SUBJECT: ISSUANCE OF AMENDMENT NO. 99 TO FACILITY OPERATING LICENSE NPF-9 AND
AMENDMENT NO. 81 TO FACILITY OPERATING LICENSE NPF-17 - MCGUIRE
NUCLEAR STATION, UNITS 1 AND 2 (TACS 71141/71142)

SAFETY EVALUATION BY THE OFFICE OF NUCLEAR REACTOR REGULATION
RELATED TO AMENDMENT NO. 99 TO FACILITY OPERATING LICENSE NPF-9
AND AMENDMENT NO. 81 TO FACILITY OPERATING LICENSE NPF-17

MCGUIRE NUCLEAR STATION, UNITS 1 AND 2

Figure 3/4 7-1
Nuclear Service Water System

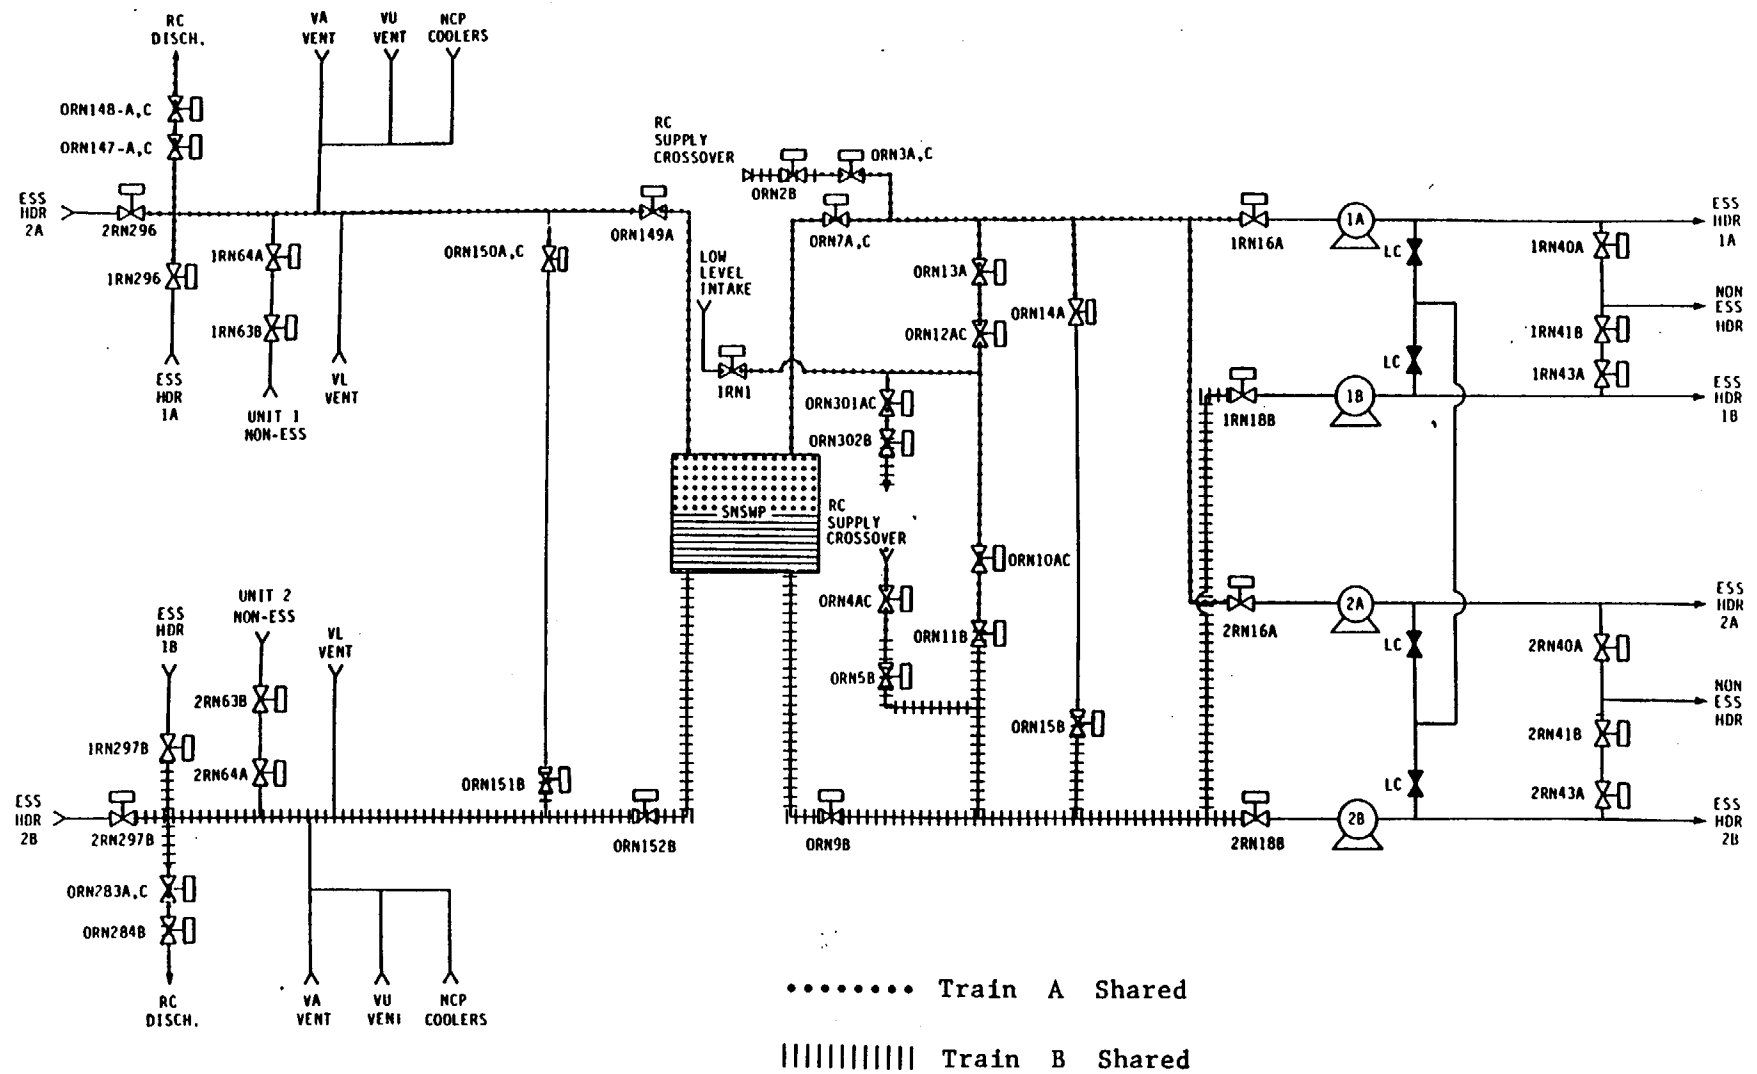
The amendments change the Technical Specifications by replacing Figure 3/4 7-1 "Nuclear Service Water System" with a more legible one and correcting a typographical error. The amendments are effective as of their date of issuance.

Also, TS Figure 3/4 7-1, "Nuclear Service Water System (NSWS) will be replaced by a more legible figure, with full (rather than abbreviated) valve designations.

The intent of TS Figure 3/4 7-1 is to designate which lines and valves of the NSWS are shared between the two McGuire units. If a shared component of the NSWS becomes inoperable, both units are affected, and both units must comply with the ACTION requirements of TS 3.7.4b, "Nuclear Service Water System." The proposed changes to Figure 3/4 7-1 make it clearer to plant operating personnel which NSWS components are shared between the two units. The revised line and valve designations do not make any change in existing system design, equipment, power source or plant operating practice.

Accordingly, the proposed changes to correct a typographical error and substitute an improved figure are of an administrative nature and have no adverse impact on safety. They are, therefore, acceptable.
